**DOCKET NO: A-98-49
II-B1-16**

**TECHNICAL SUPPORT DOCUMENT FOR SECTION 194.23
REVIEW OF THE 2004 COMPLIANCE RECERTIFICATION
PERFORMANCE ASSESSMENT BASELINE CALCULATION**

**U. S. ENVIRONMENTAL PROTECTION AGENCY
Office of Radiation and Indoor Air
Center for the Waste Isolation Pilot Plant
1310 L St., NW
Washington, DC 20005**

March 2006

Figure 6-1. Initially Anaerobic, Amended Humid Experiments
(Gillow and Francis 2003)

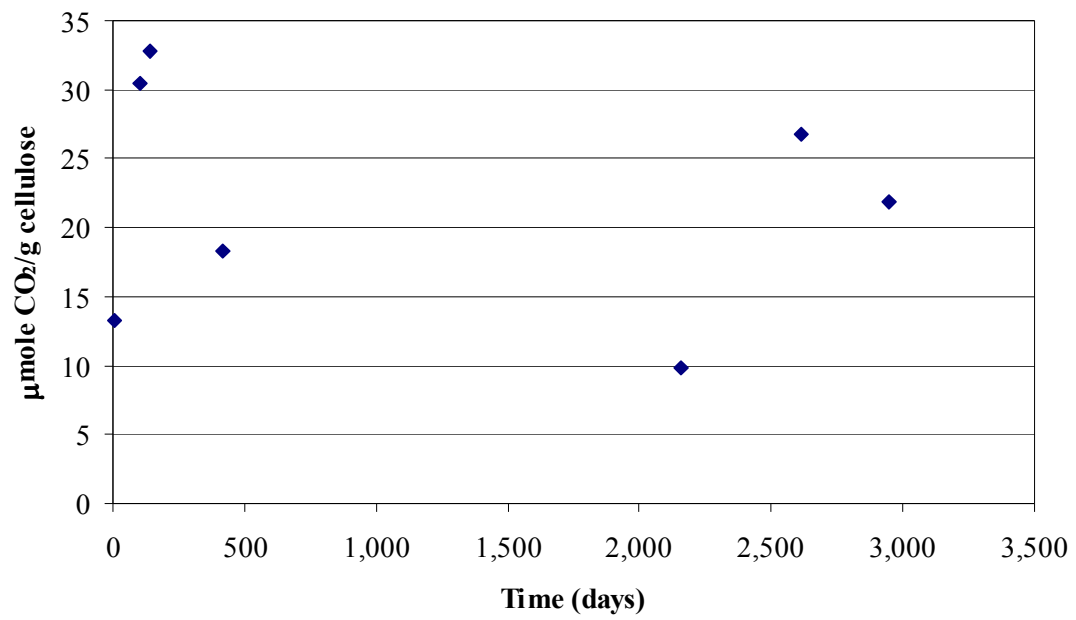
Nemer et al. 2005 used data from the unamended experiments to determine the maximum long-term gas generation rate under humid conditions. The reasons for excluding data from the humid amended experiments were not stated. However, examination of the data reported by Gillow and Francis 2003 shows that the long-term rate for the humid amended experiments was essentially zero (Figure 6-1), and the lower limit for the humid gas generation rate was assumed to be zero by Nemer et al. 2005. The Agency successfully reproduced the calculation of the maximum long-term humid gas generation rate using the same carbon dioxide data as Nemer et al. 2005 (Appendix C). The assumption that the humid gas generation rate would range between this maximum rate and zero as observed in the amended humid experiments is consistent with the available experimental data.

Figure 7-1. Felmy et al. 1991 ThO₂(am) Solubility Data Difference Value Histogram
 (Source: ASTP.2005.04A_Xiong et al, An Sol Unc, Rev 1, Spreads, 2 of 2.xls)
 This distribution was used to develop the +IV actinide solubility uncertainty for the PABC.

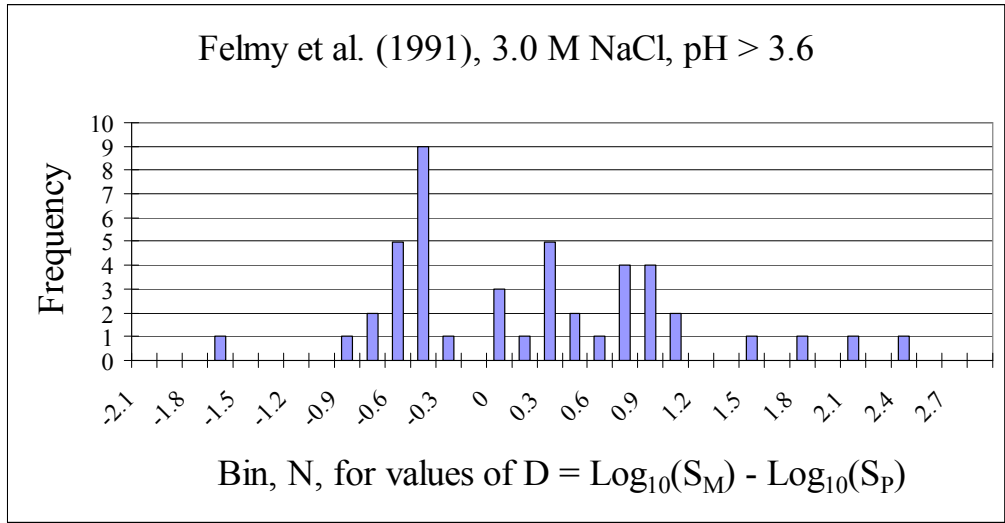
For example, the distribution of D values for the Felmy et al. 1991 ThO₂(am) data is illustrated in Figure 7-1. Even though the thermodynamic data for ThO₂(am) in FMT_050405.CHEMDAT were derived from this study, the range of difference values was relatively large, with D values that ranged from -1.75 to 2.39. The distribution is weighted somewhat toward positive D values, indicating that the model tended to more often underpredict measured solubilities. This example indicates that using data included in the development of the thermodynamic database may not result in a solubility uncertainty distribution that is closely grouped or symmetric around D values of zero. Therefore, in future determinations of actinide solubility uncertainty distributions, it would be advisable to include all available data, even if it was used to develop

Figure 8-5. The CRA-Revised (PABC) Full Mining Zones Overlaid with the 1996 CCA (red) and CRA delineations (blue)
 (Source: Lowry and Kanney 2005)

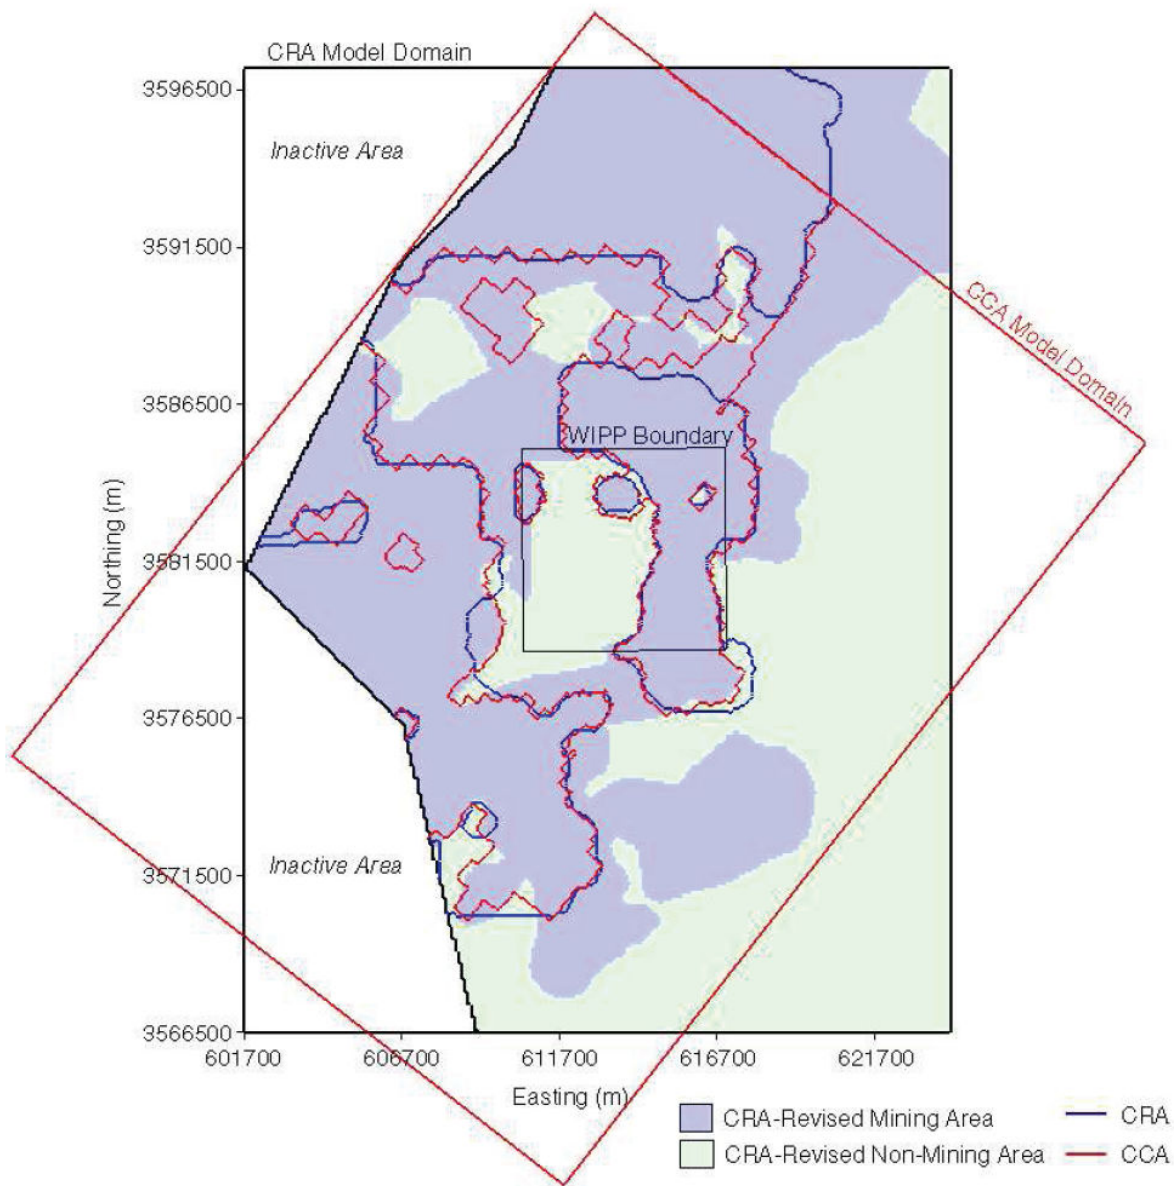
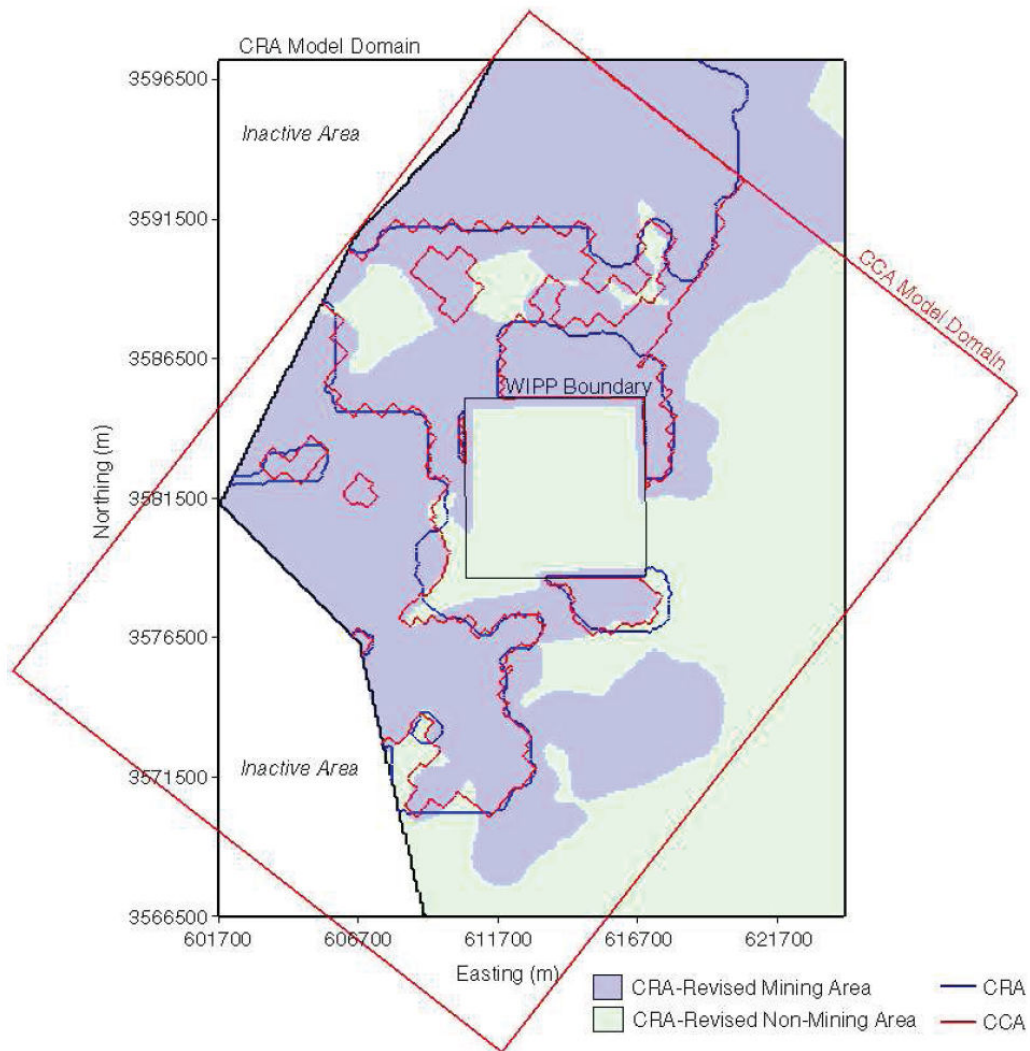
The model domains of the CCA grid, CRA grid, and the CRA-revised (i.e., PABC) grid for both the full- and partial-mining scenarios are shown in Figures 8-5 and 8-6, respectively. Results show that for both the full- and partial-mining scenarios, the median particle travel times of 75,774 and 129,202 years are 4.14 and 7.06 times longer than for the non-mining scenario (18,289 years). The increase in transmissivity due to mining increases the relative flow rate through the mining zones, with a corresponding decrease in flow through the non-mining zones. This decrease in flow through the non-mining zones produces longer travel times for the mining scenarios. Comparing the full-mining scenarios of the PABC analysis to the CCA and CRA calculations, the median travel times are approximately 2.53 and 1.14 times longer, respectively. For the partial mining case, the median travel time for the PABC is 9.33 times greater than the median for the CCA, and 2.67 times greater than the CRA. DOE attributes this increase in the travel time over the CRA to the higher percentage of area deemed as mining zone. DOE points out that unlike the CRA, a negative correlation was found in the PABC analysis between the travel times and the random mining factor (the higher the random mining factor, the longer the particle travel time). DOE believes this is also due to a higher percentage of mining zone area in the PABC analysis as compared to the CRA. With a higher percentage of mining area, the random mining factor has a larger influence on the regional flow regime. As the mining factor is increased, the flow through the non-mining areas is decreased, producing longer travel times and the negative correlation. However, additional analysis shows that most of the travel time variability is due to differences in the base T fields and not the random mining factor.

By eliminating the exclusion zone around the existing oil and gas wells the DOE has addressed the Agency's concern with respect to the mining scenario.

Figure 9-5. Schematic of the Stratigraphy Surrounding the Raised and Unraised Sections of the Repository

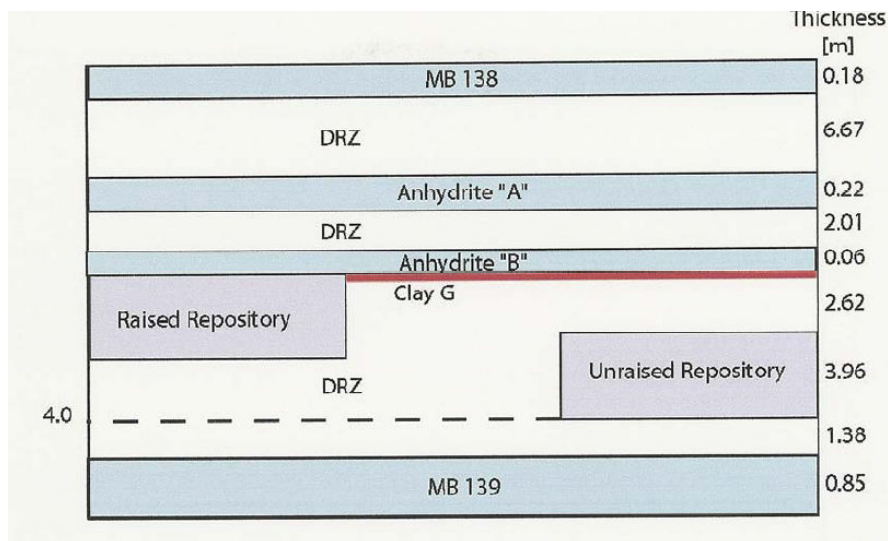
Figure 9-5 (Stein and Zelinski 2003c) compares the raised and unraised repository configurations in relation to the surrounding stratigraphy. In particular, in the raised half of the repository, the distance through the lower DRZ from the repository floor downward to MB 139 increases from 1.4 m to approximately 3.8 m. This change means that fracturing associated with floor heave will likely be reduced in this part of the repository.

The Agency believes that the processes should be modeled as realistically as reasonably practicable. Since the rock will fracture once lithostatic pressures are exceeded, the DRZ should be allowed to fracture. Furthermore, the pressure distribution within the repository should be relatively uniform at both the top and the bottom. Therefore, DOE's conceptualization that both the upper and lower DRZ's can fracture is appropriate.

Figure 10-2. Combined Mean DBR CCDFs for All PAVT and PABC Replicates
 (Source: Vugrin 2005h, Figure 4)

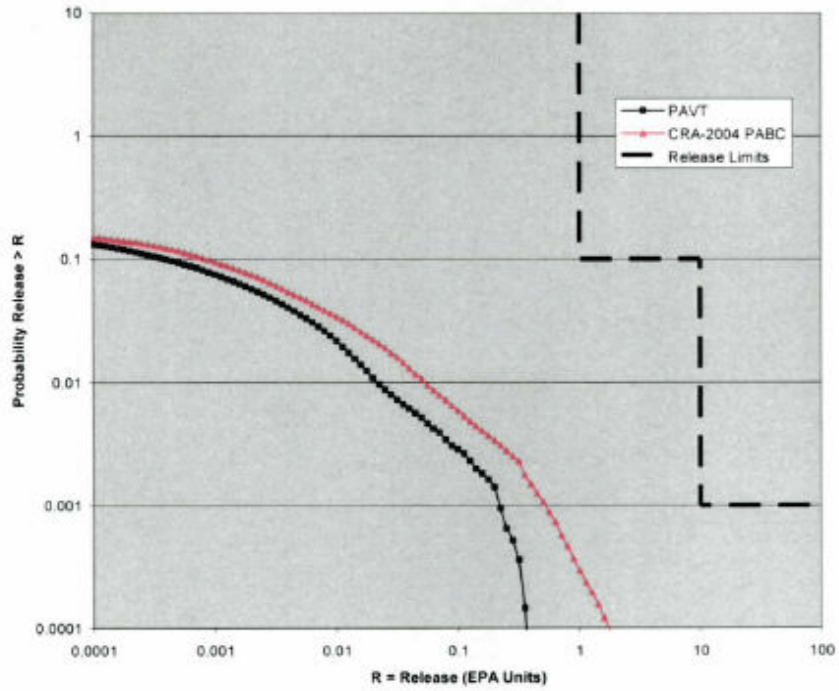
Figure 10-2 illustrates the differences between projected direct brine radionuclide releases for the PAVT and PABC. Comparison of these projections shows that the projected contribution of DBRs to total radionuclide releases has increased. The increase is most notable at probabilities less than about 0.002, where mean direct brine radionuclide releases have become the greatest contributors to total mean direct release in the PABC (see, for example, Leigh et al. 2005a, Figure 6-6). This is attributed primarily to changes in the PABC that increased actinide solubilities (Leigh et al. 2005a, Section 6.4). These changes included increased solubilities and revising the solubility uncertainty range (Leigh et al. 2005a, Sections 2.5 and 2.6). Given these changes, the calculated increase in DBR radionuclide releases is reasonable.

Figure 11-3. Combined Total Mean Normalized Release CCDFs for All PAVT and PABC Replicates
 (Source: Vugrin 2005h, Figure 1)

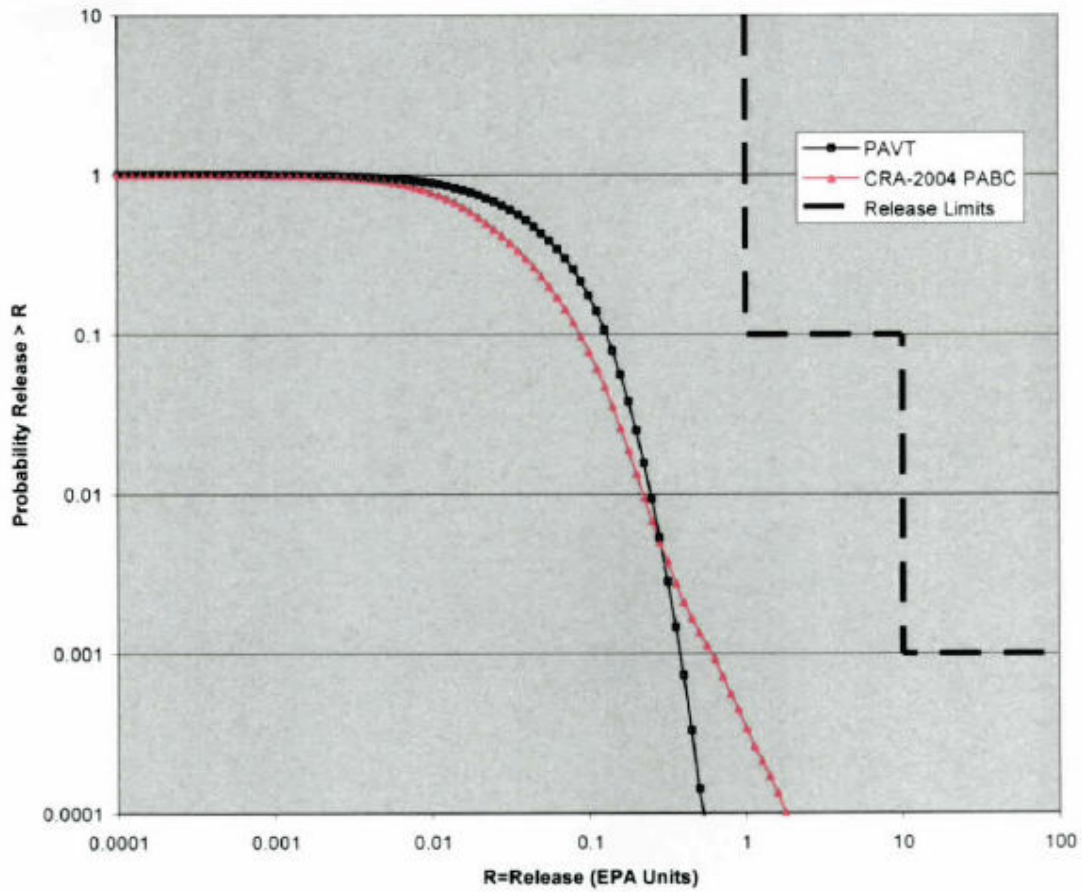
The increased releases at low probabilities in the PABC illustrated in Figure 11-3 reflect the increased DBRs and, as described in Section 10.2.2, are primarily due to higher brine saturations resulting from lower microbial gas generation rates, and to changes in the PABC that increased actinide solubilities. As can be seen from Table 11.1, for the PABC both the calculated mean releases and the upper 95% confidence levels on the mean have remained less than the regulatory limits at both 0.1 and 0.001 probabilities. Therefore, the Agency concludes that the WIPP continues to comply with the containment requirements of 40 CFR 191.13.
